# Access Compliance Report

## Public Rights-of-Way

### (Curb Ramps)

Intersection ID: 2576	Main Street: CAMBRIDGE_BAY_DR	Cross Street: WHISTLER'S_CHASE_DR	Location: E
ADA ID: C995D432783C	Ramp Type: PerpDiag	Initial Pass/Fail: Fail	Overall Compliance: No
Severity Score: 21.25			
Codes/Mitigation Info/Possible Solution		Field Measurements/Component Compliance

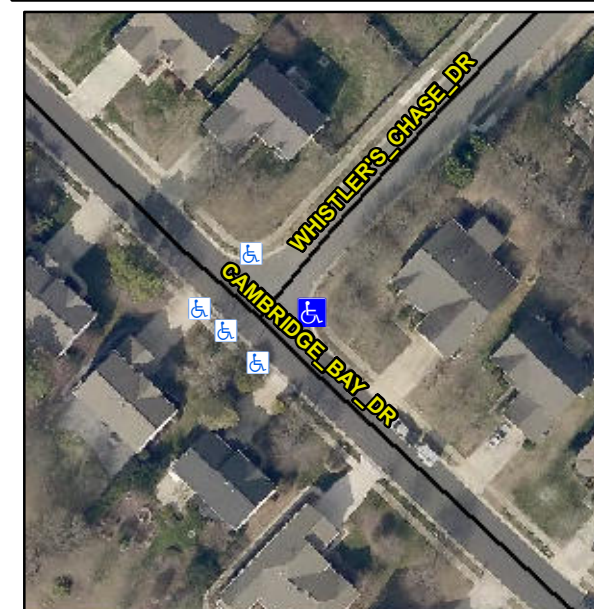
**Not Found, R304.5.1, R304.2.2**

Compliance	Description	Data	Compliance	Description	Data
N/A	Ramp Length (in)	48.0	No	Ramp Slope (%)	10.3
No	Ramp Width (in)	44.0	Yes	Ramp XSlope (%)	1.3
N/A	Flare Type LT	N/A	N/A	Flare Type RT	N/A
N/A	Flare Slope LT (%)	N/A	N/A	Flare Slope RT (%)	N/A
N/A	Flare Traversable LT?	N/A	N/A	Flare Traversable RT?	N/A
N/A	Landing Length (in)	N/A	N/A	DWS Provided?	N/A
N/A	Landing Width (in)	N/A	N/A	DWS Contrast?	N/A
N/A	Landing Slope (%)	N/A	N/A	DWS Length (in)	N/A
N/A	Landing X Slope (%)	N/A	N/A	DWS Full Width?	N/A
N/A	Landing Curb? (Y/N)	N/A	N/A	DWS Offset (in)	N/A
N/A	Shared Landing?	N/A			
N/A	Gutter Ponding?	N/A	N/A	Gutter Slope (%)	N/A
N/A	Gutter Lip Ht (in)	N/A	N/A	Gutter X Slope (%)	N/A
N/A	Painted X Walk1?	No	N/A	Painted X Walk2?	No
	X Walk 1 Direction	To NW		X Walk 2 Direction	To SW
N/A	X Walk 1 Width (in)	N/A	N/A	X Walk 2 Width (in)	N/A
	X Walk 1 Slope (%)	4.5		X Walk 2 Slope (%)	3.7
	X Walk 1 X Slope (%)	3.8		X Walk 2 X Slope (%)	7.2

**Remove & Replace Curb Ramp With Two New Directional Ramps or Equivalent.**
